Explanation of IC-ENC Validation Processes

IC-ENC form P007: Validation Report

Cell Information:
Cell Name – XY456123.000
Edition Number - 1
CRC - CFCC1D1B

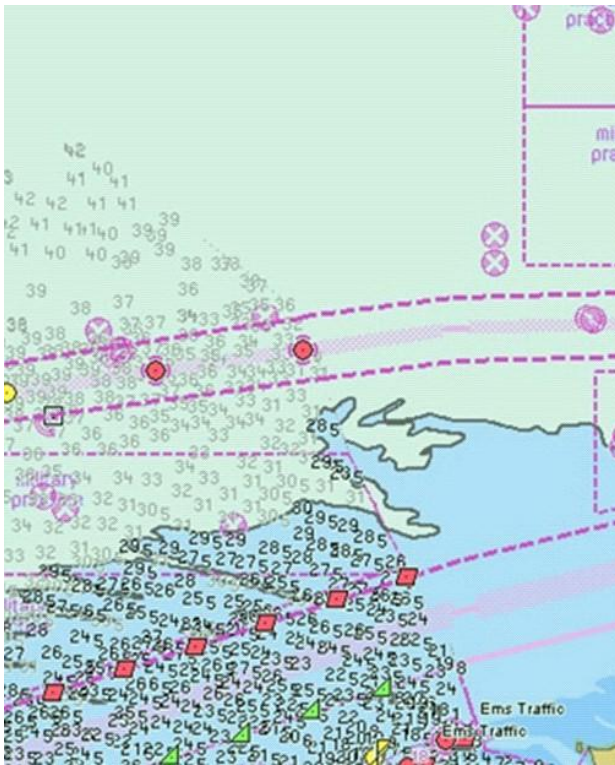
Fig. 2 - An example of where two HOs have produced ENCs up to their data limits, but the different approaches to the use of SCAMIN has resulted in a dataset that is not seamless. The ENC to the west does not have SCAMIN attributed to the soundings, resulting in much clutter in the shoaler areas, and the ENC to the east has a SCAMIN value attributed which is too large, resulting in the soundings being entirely removed from the display.

This is a good example of an issue where IC-ENC would liaise with the HOs to achieve a more seamless display for the mariner, each HO receiving different advice about SCAMIN:

Fig. 3 - An example of where a single HO has produced two adjacent usage band ENCs, but one of them is less up-to-date, resulting in mismatched TSS objects.

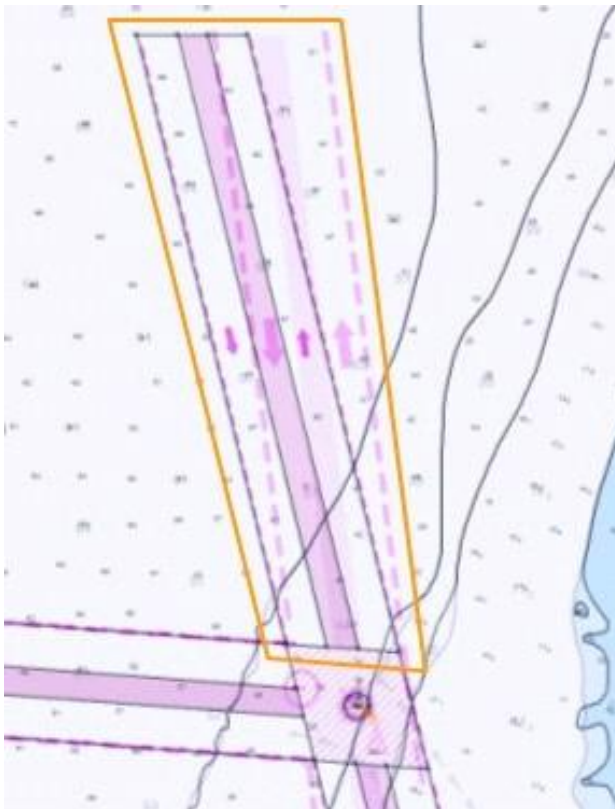
This is a good example of a problem for which IC-ENC would ask for an immediate response, given the importance of the TSS objects.
